COUNTY OF SANTA CRUZ

Planning Commission County of Santa Cruz 701 Ocean Street Santa Cruz, CA 95060 Agenda Date: March 11, 2009

Time: After 9 AM APN: 028-143-44 Application: 08-0139

Subject: Appeal of the Zoning Administrator's decision to approve a Coastal Permit and Residential Development Permit for Application 08-0139; a proposal to construct a 2nd-story addition to an existing two story single family dwelling.

BEST ELEVATION (REAR VIEW)

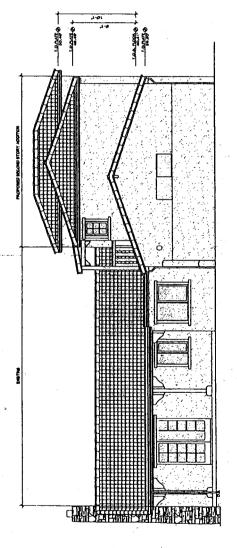
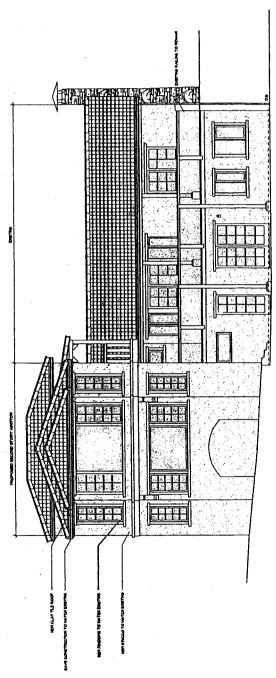
Planning staff originally noted that the addition, while not actually being a third story as defined in the County Code, looked like a three story building from the elevations because of the under floor that daylights on that side. However, the revised plans approved by the Zoning Administrator have been scaled back in size by approximately 20 feet on each side of the addition facing the beach and the building has been redesigned with a square bay window, an archway from the ground level to the top of the first floor, and brackets and windows consistent with the original portions of the structure. These changes improve the appearance and significantly reduce the apparent mass facing the beach. The added arch connects the first story to the ground and lessons the 3 story effect of the under floor. The final approved elevation drawings (Exhibit 1C) reflect the modifications to the elevations facing the beach. The applicant has also provided a revised simulation (Exhibit 1D).

The applicant submitted a revised project design to address these comments. The project now complies with the recommendations of the Urban Designer in that the wall plane on the north side has been provided additional design treatment including a belly band detail located between the first and second floor, divided windows consistent with the windows throughout the existing dwelling, an additional wall extension similar to the one shown on the original plans, and a hipped roof on the east end of the building. These design features articulate the north wall plane and create an elevation more consistent with the overall character of the building, which unifies the overall building design. Furthermore, the beach elevation has also been modestly scaled back in size, provided brackets, a belly band, and divided windows consistent with the existing dwelling.
